2009 Vermont Yankee Initial NRC Examination Written Examination Review

In accordance with Entergy procedure EN-TQ-105 "NRC Initial License Examination, Development and Administration", and NUREG 1021, Revision 9, Supplement 1, Sections ES-403 and ES-501, an examination analysis was conducted on the 2009 Vermont Yankee NRC Written Examination. This analysis included a detailed review of each question missed by 50% or more of the applicants.

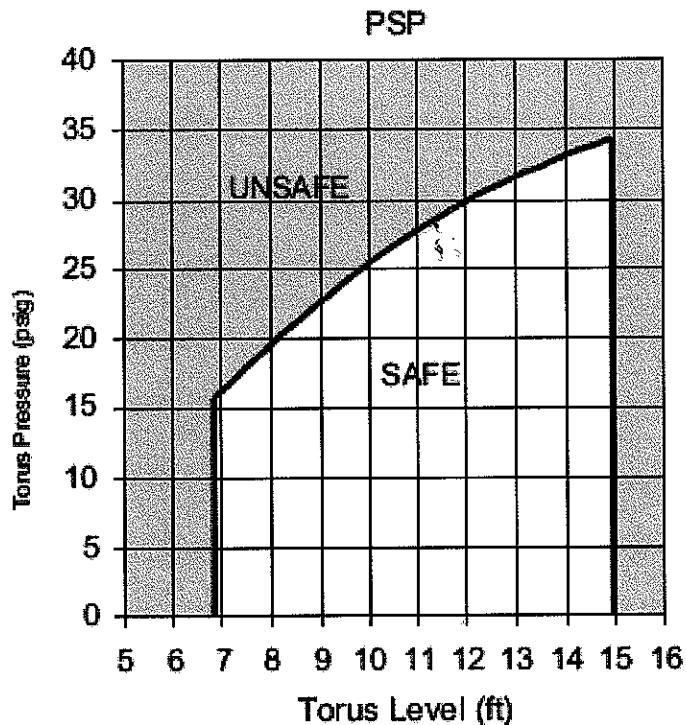
The question asks "determine the LOWEST pressure at which containment integrity could no longer be assured"?

The stem of the question had a value of 11.8 feet Torus level. That level should have stated 10.8 feet.

The correct answer stated in the exam answer key was A; Using the information provided in the question stem and the supplied reference of the PSP curve, the candidates plot the position of 27 psig Torus pressure and 11.8 feet Torus level. This results in a point residing in the safe region of the PSP curve. Therefore containment integrity would still be assured and this answer would be incorrect.

During the validation process this question was modified several times with Torus Water Level being the center of the discussions. The final conclusion reached was the Torus Water Level provided in the stem should be 10.8 feet instead of 11.8 feet. The agreed upon recommendation was lost in the revision process and the stem was not modified as requested during the validation process.

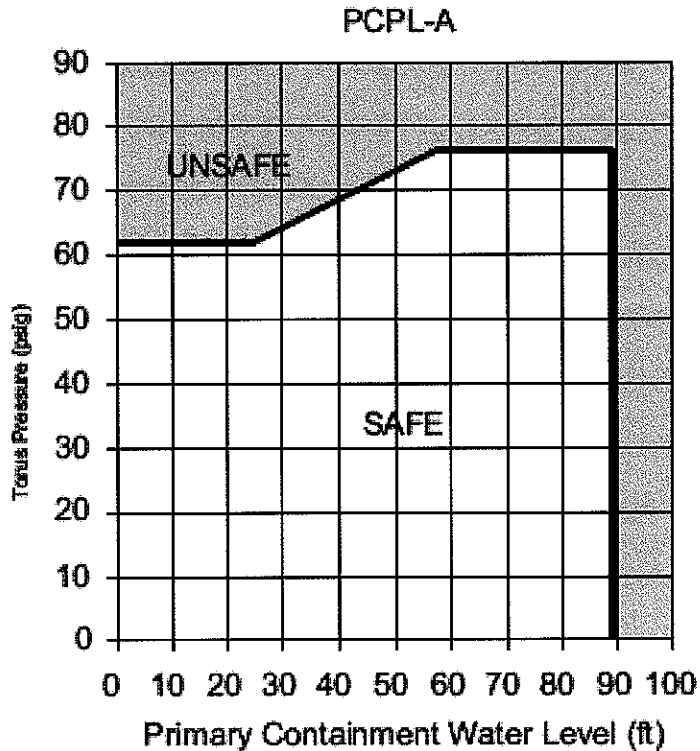
Distracter “B” states 62 psig Torus Pressure. This answer is INCORRECT with the stated level of 11.8 feet. Using the supplied reference of the PCPL-A curve the candidates would plot the position of 62 psig and 11.8 feet Torus level. This results in a point residing on the maximum primary containment pressure line of PCPL-A. Therefore containment integrity would no longer be assured at this pressure, however it is not the lowest pressure.

There is no correct answer.

Remove the question from the exam.
